**TOWN OF PORTOLA VALLEY
ARCHITECTURAL AND SITE CONTROL COMMISSION (ASCC)
Monday, July 22, 2013
Special Field Meeting (time and place as listed herein)
7:30 PM – Special ASCC Meeting
Historic Schoolhouse
765 Portola Road, Portola Valley, CA 94028**

TO: ASCC
FROM: Tom Vlastic, Town Planner
DATE: July 22, 2013
RE: Agenda for July 22, 2013 ASCC Meeting

4b. ARCHITECTURAL REVIEW FOR HOUSE ADDITIONS & DRIVEWAY MODIFICATIONS, AND SITE DEVELOPMENT PERMIT X9H-656, 468 WESTRIDGE DRIVE, CROUSE/DORAHY

SHEET: A-1.2

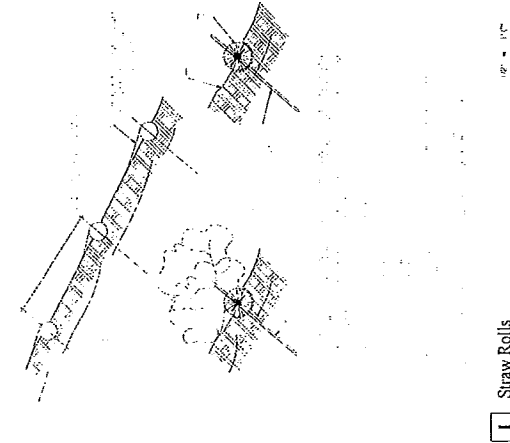
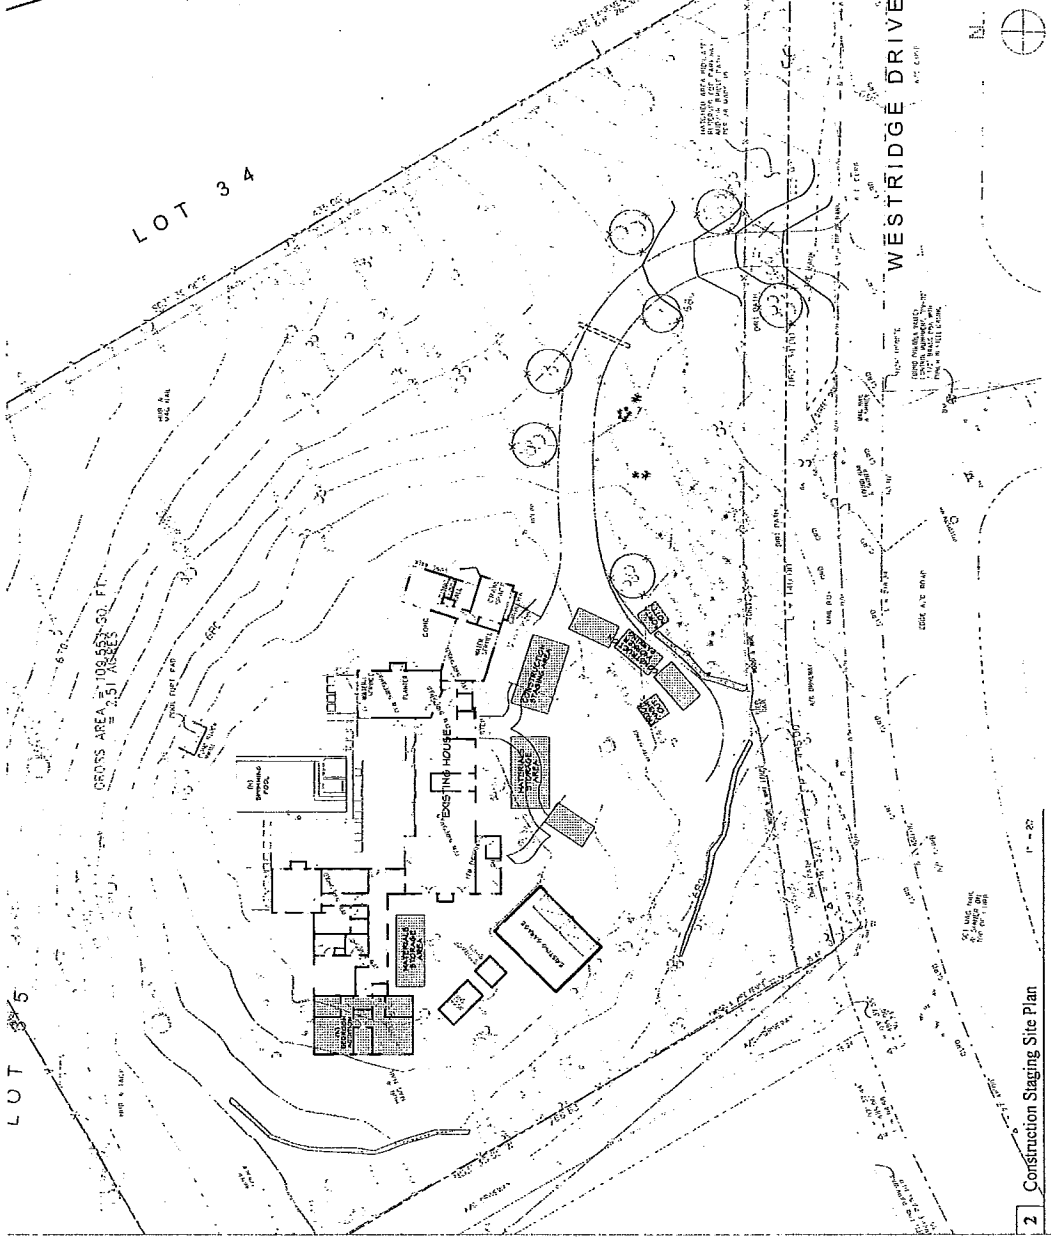
The driveway plan has been developed to avoid trees on site, but care would be needed in line with project arborist recommendations, to ensure trees are protected from construction impacts. The recommendations are not referenced on the tree protection plan, Sheet: A-1.2, but should be added to the final construction and building permit documents assuming project approval as proposed.

Reinhardt Residence
 140 Pinon Drive, Perito Valley, CA
Site Preparation Plan L-1

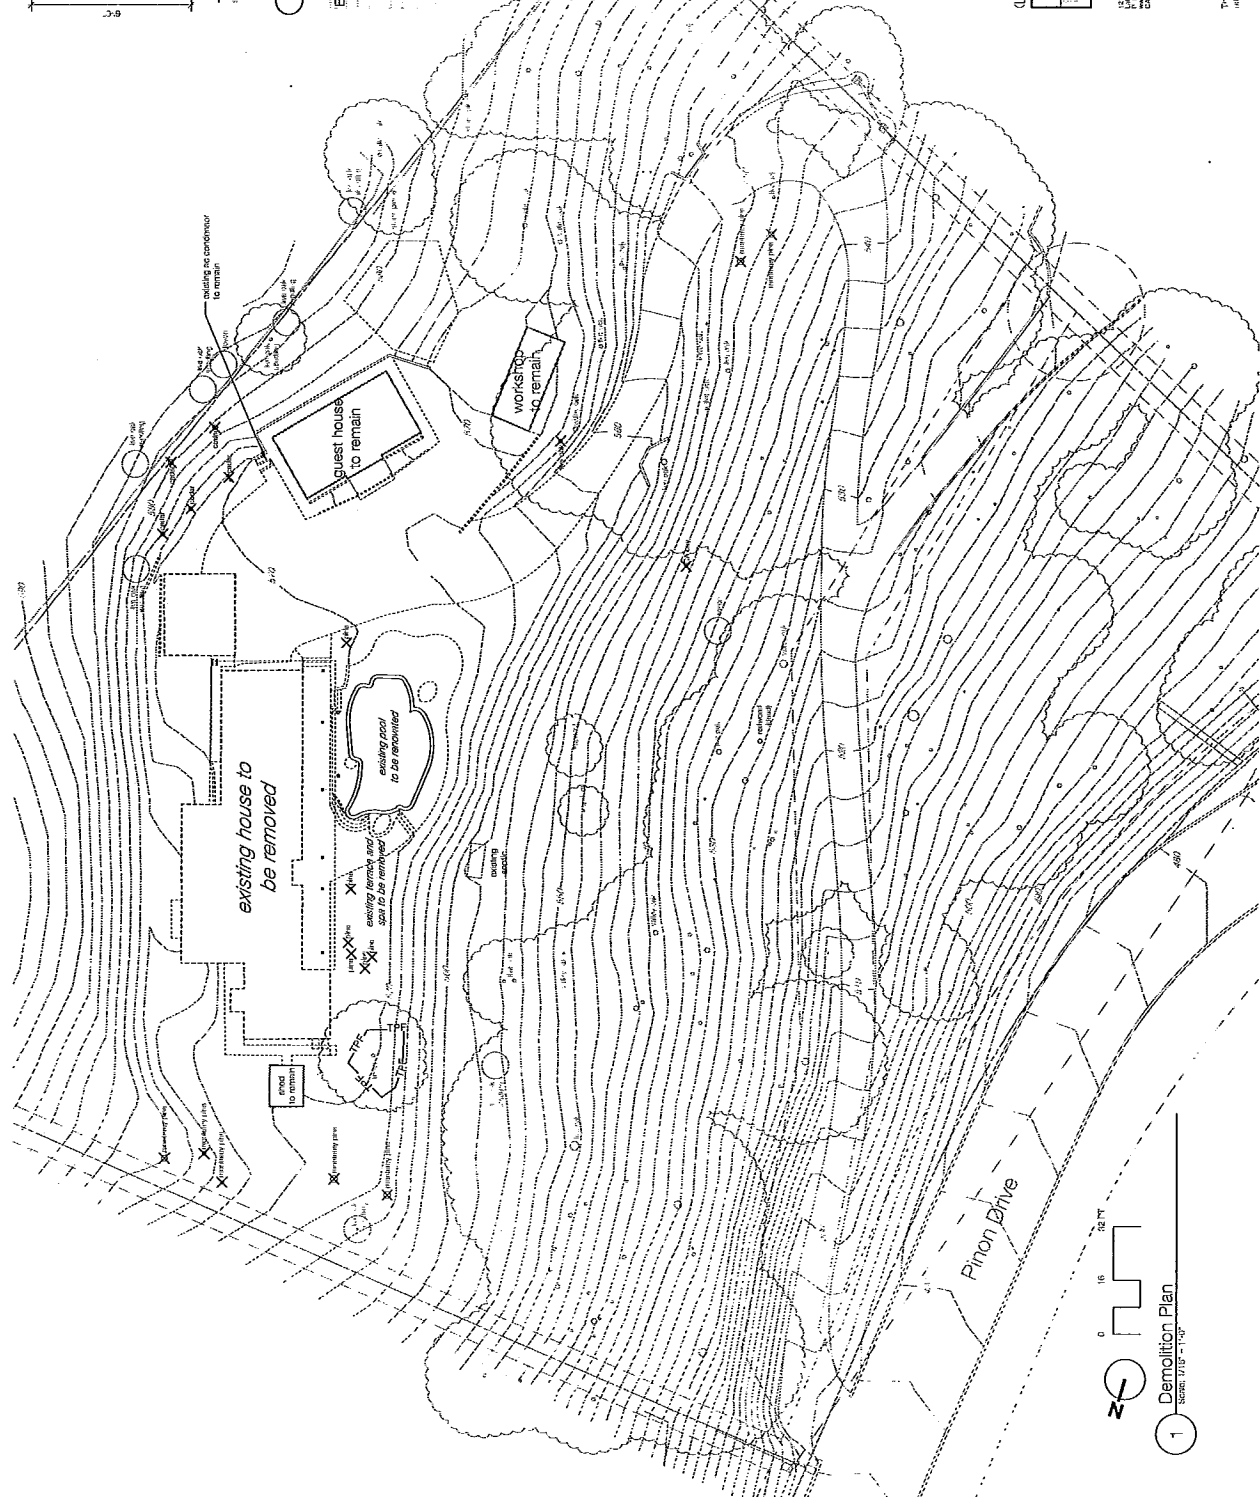
As shown on Sheet L-1, a number of existing pines, cedars, one dead redwood, and one bay would be removed. In addition, one small live oak is to be removed. It is immediately west of the boat house/workshop, and removal is proposed due to

A6.0

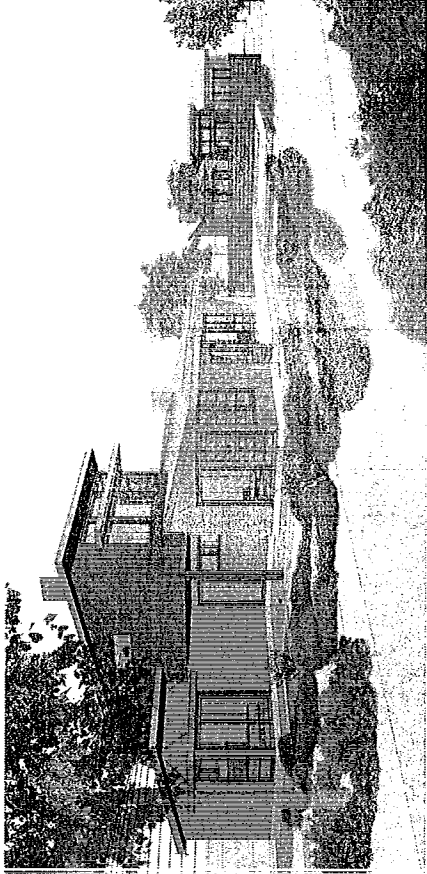
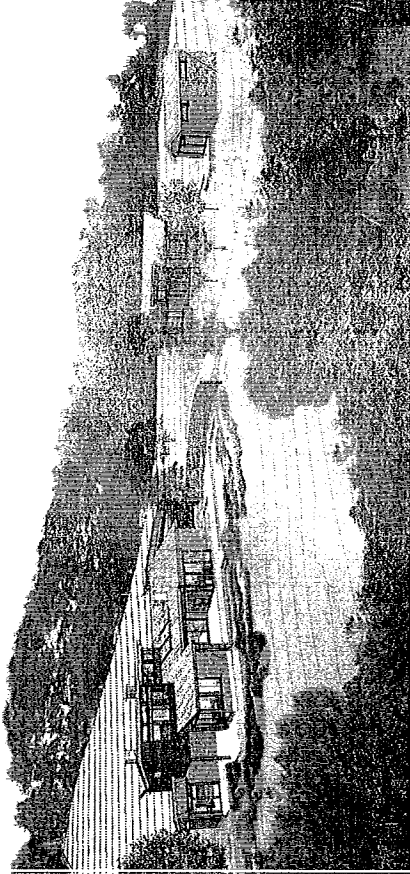
4. **Project Design and Exterior Materials.** The proposed architecture was discussed above and is best appreciated from review of the plan elevation and 3D view sheets (i.e., Sheets A3.0, A3.1 and A6.0). The design incorporates low pitch roof forms, and a variety of architectural details that add interest, and shadow patterns and also helps ensure minimum potential for excess massing or scale. The proposed finish treatments for the house, guest house and boat house/workshop remodeling include:
